ADDENDUM NO. 1

DEERFIELD
Federal Aid Project No. BFL(BR-OFF)-0032(052)X
Bridge Replacement, D-06-001,
Upper Road Over Deerfield River

Transmitting revisions to the Contract Documents as follows:

Revised Plan Sheets 47, 49, 50, 51, 52, 61 & 63 of 92.

PIER 1 PLAN AND ELEVATION

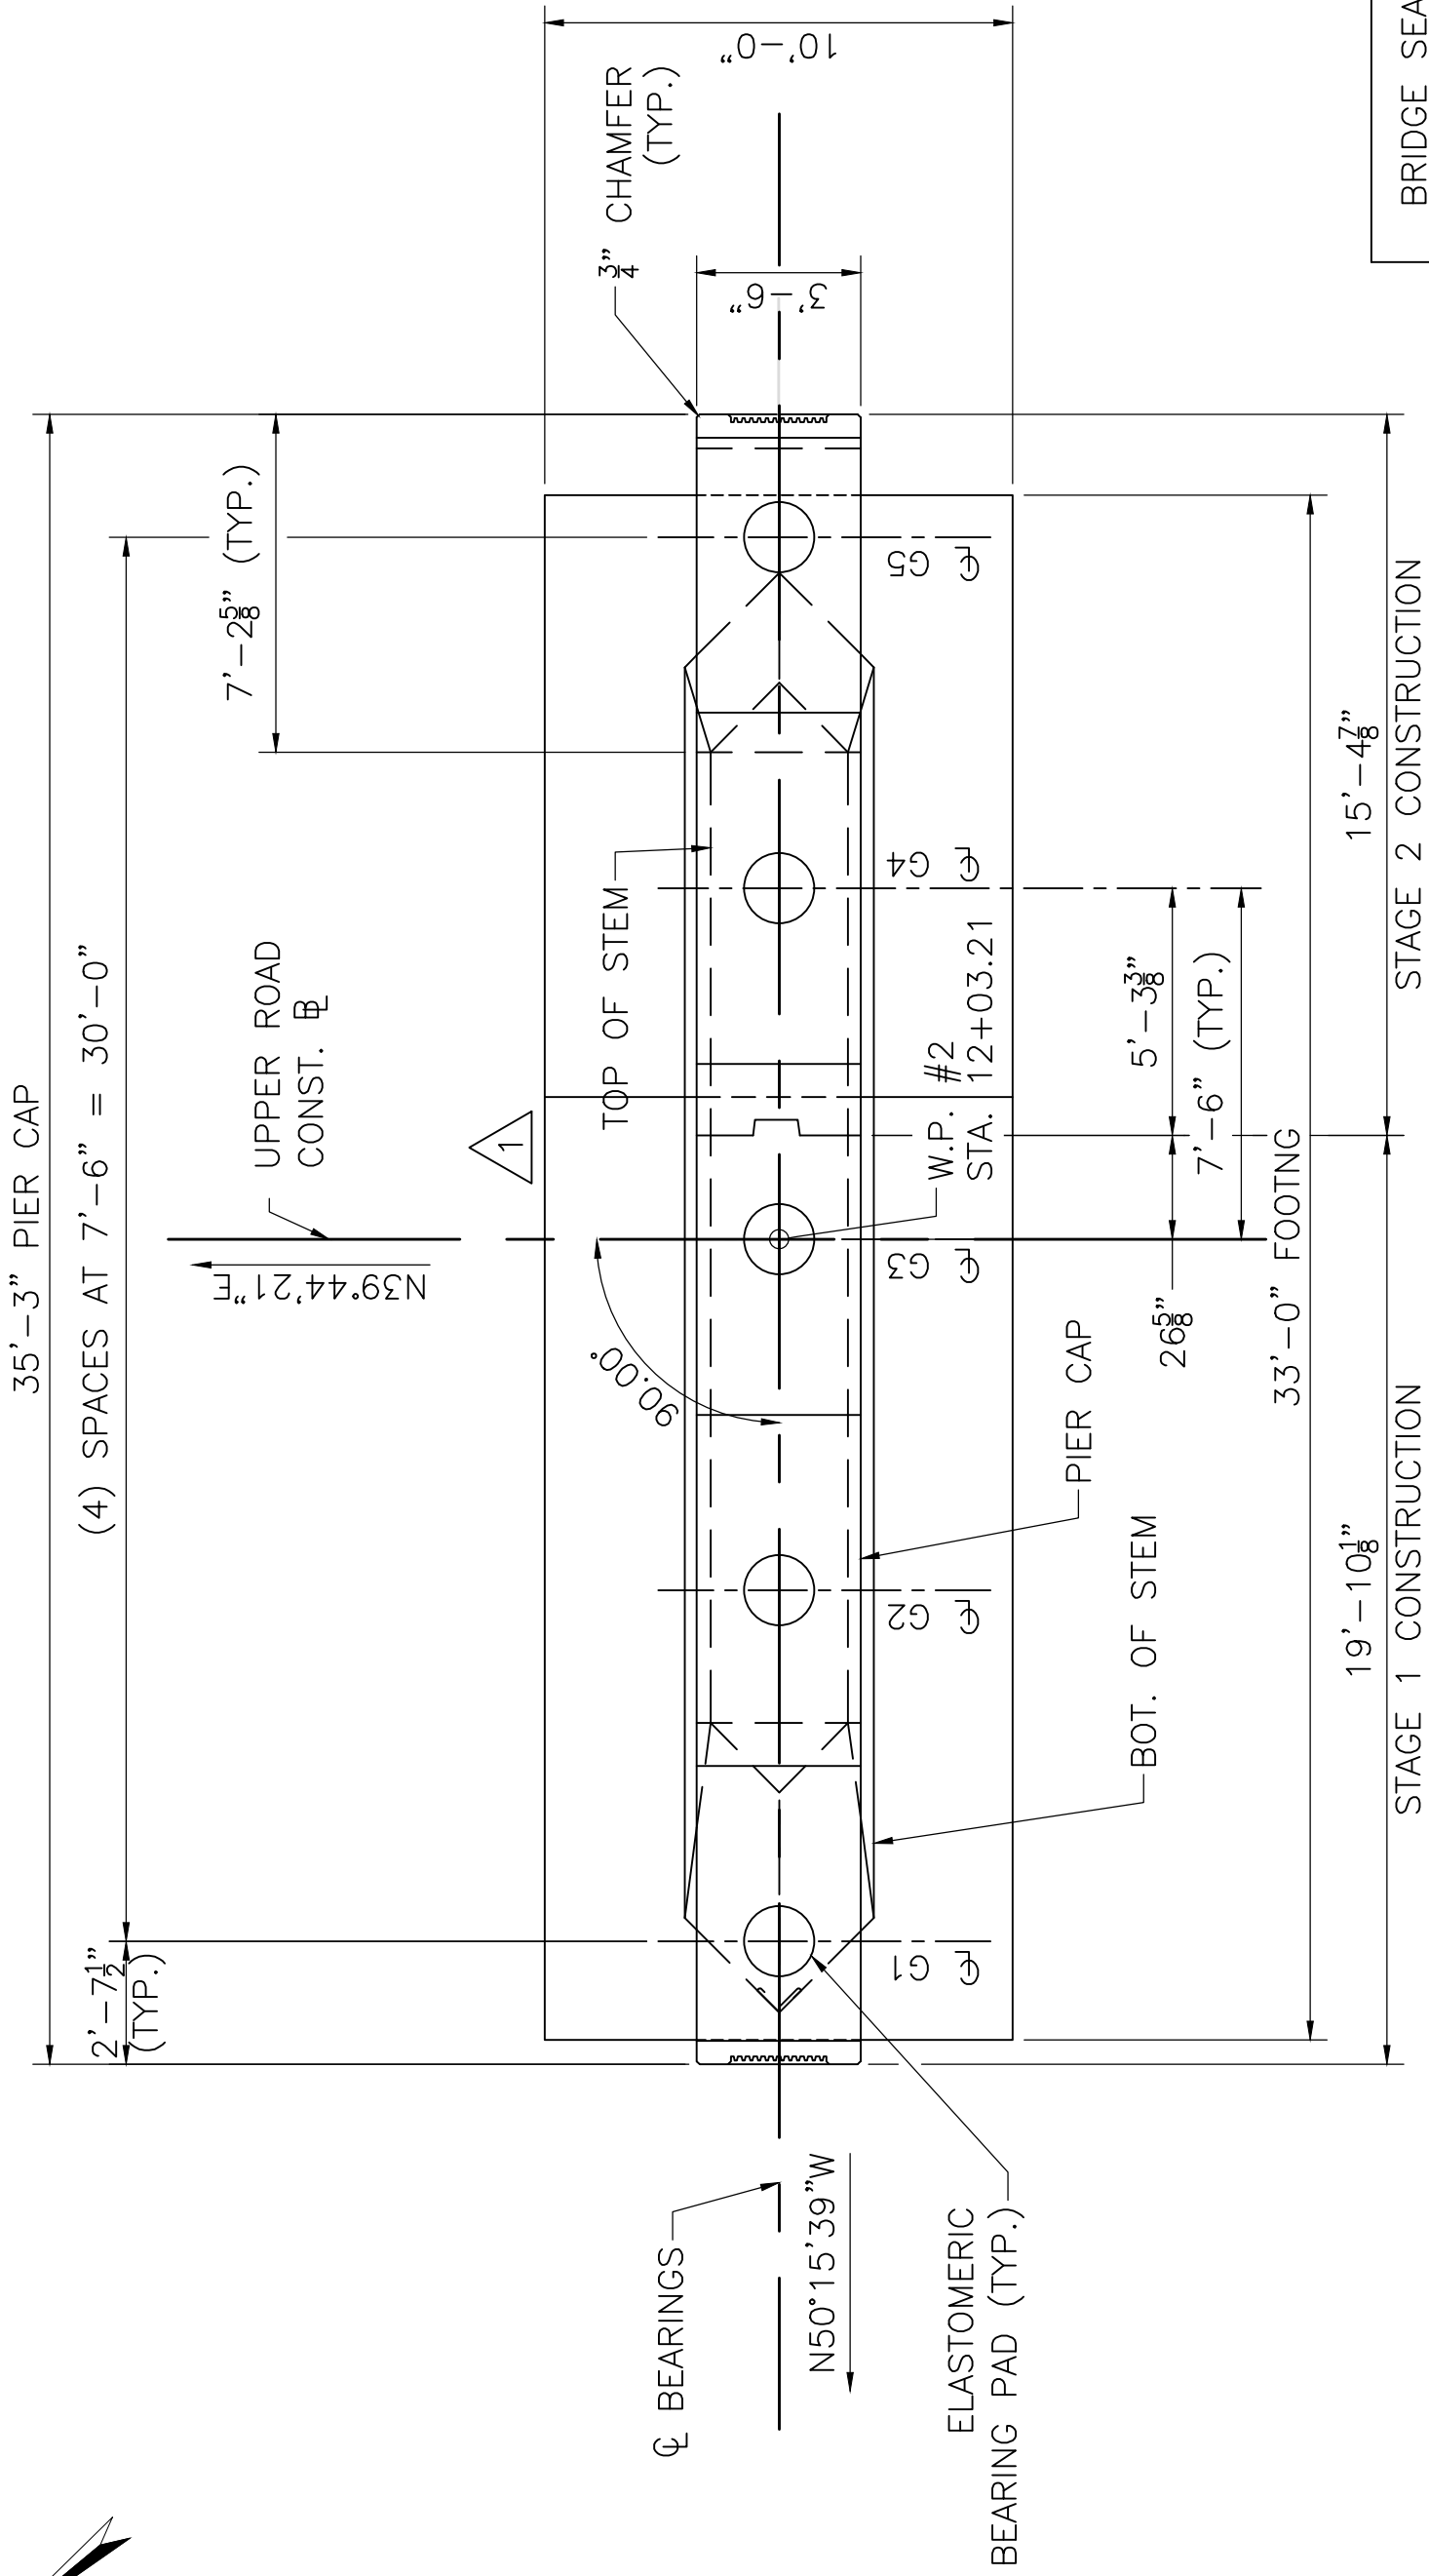
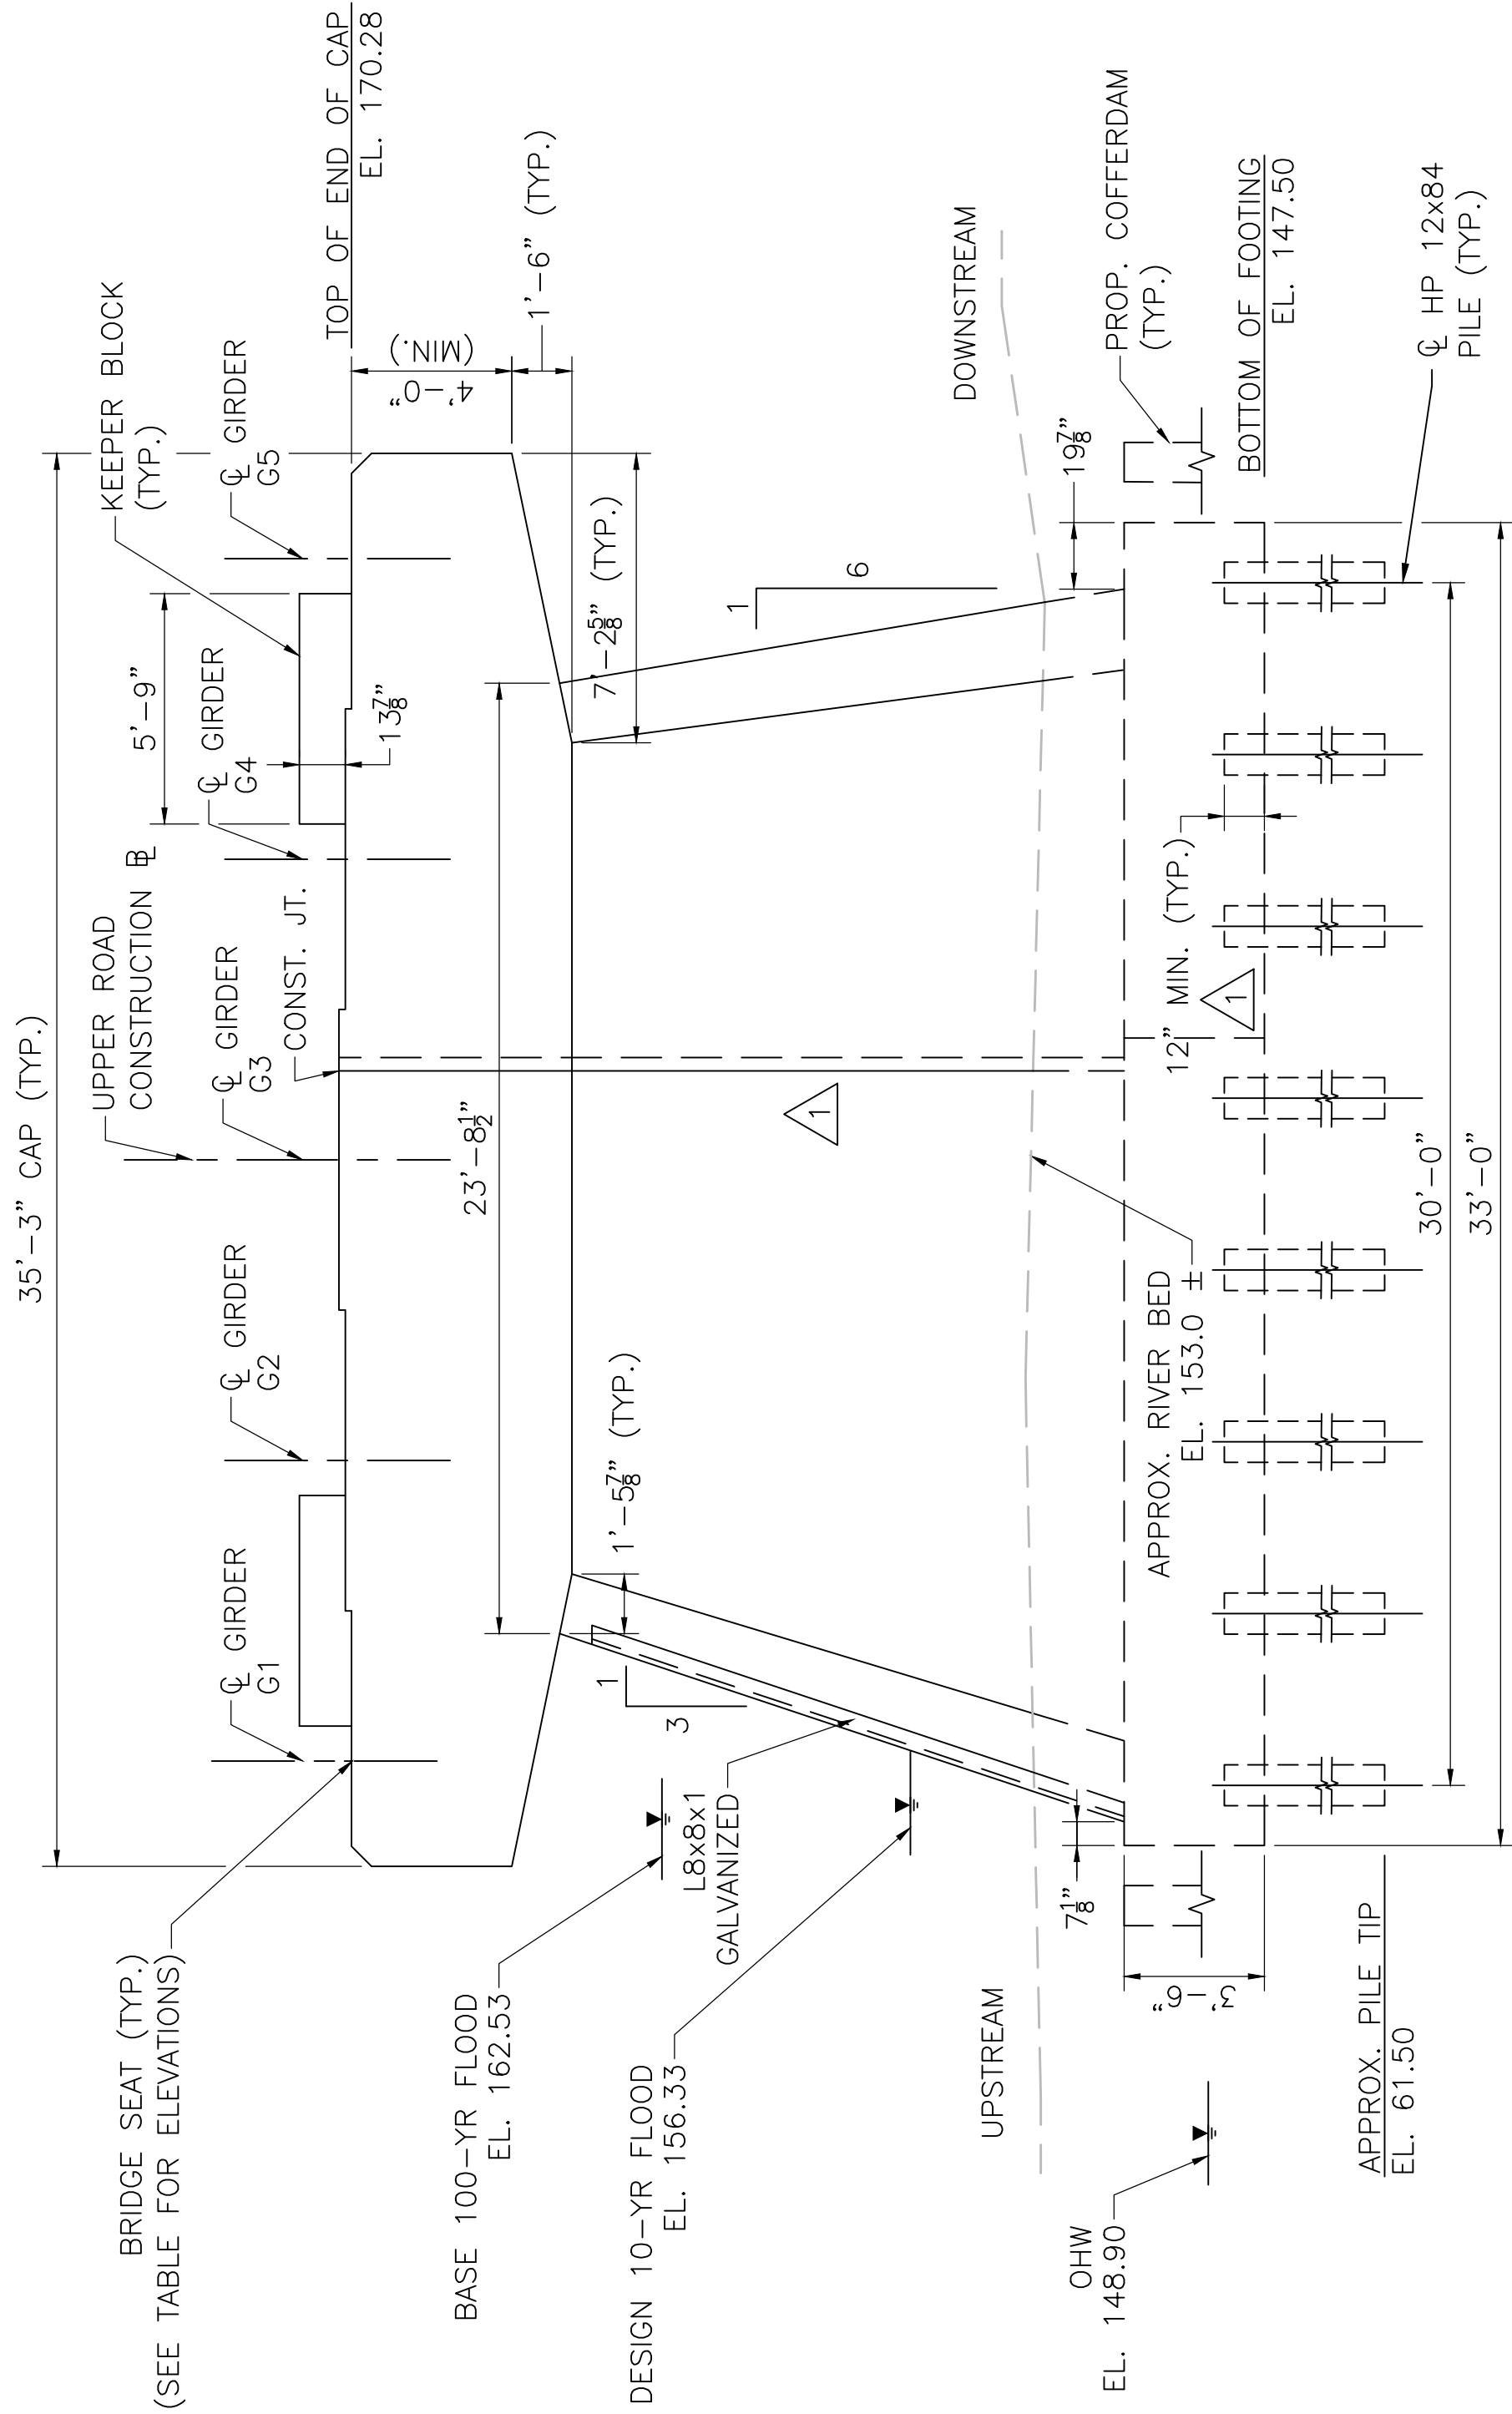
Can Pier 1 be installed and built with construction joints in the footing and stem for the phased construction approach, like what is shown for construction joints in the south abutment?

For pile locations requiring multiple splices due to headroom limitations, please confirm the required pile driving criteria, including any restrictions on driving spliced piles, maximum allowable hammer energy, splice inspection requirements, and any special procedures necessary to achieve the specified pile capacity.

See revised sheets 47 of 92 (11 of 41), 49 of 92 (13 of 41), 50 of 92 (14 of 41), 52 of 92 (16 of 41), 61 of 92 (25 of 41), and 63 of 92 (27 of 41) issued via this addendum.

- DETERMINATION OF THE DRIVEN PILE RESISTANCE, PILE DRIVING CRITERIA, AND PILE INTEGRITY SHALL BE PERFORMED ON THE FIRST PILE INSTALLED FOR EACH PHASE OF PROPOSED PIER NO. 1 CONSTRUCTION USING DYNAMIC TESTING WITH A RESISTANCE FACTOR OF 0.65. PILES SHALL BE INSTALLED TO ACHIEVE A FACTORED DRIVEN RESISTANCE EQUAL TO OR GREATER THAN THE FACTORED AXIAL DESIGN LOAD NEGLECTING AN ESTIMATED 2.14 KIPS OF SIDE RESISTANCE THAT WILL BE LOST DUE TO 5.00 FEET OF DESIGN SCOUR.

- ALL PILE SPLICES SHALL BE EITHER BUTT JOINTS MADE USING COMPLETE JOINT PENETRATION WELDS OR MECHANICAL TYPE SPLICES INSTALLED IN ACCORDANCE WITH THE APPROVED INSTALLATION NOTES. ALL SPLICE WELDS WITHIN 37.5 FEET FROM PROPOSED PIER 1 SHALL BE 100% INSPECTED USING UT.

June 26, 2026	STAGE 1 LIMIT ALTERED
May 30, 2026	ISSUED FOR CONSTRUCTION
DATE	DESCRIPTION
THIS SHEET IS APPROVED FOR CONSTRUCTION BY MASSDOT AUTHORIZED SIGNATORY: _____	
STATE BRIDGE ENGINEER	
USE ONLY PRINTS OF LATEST DATE
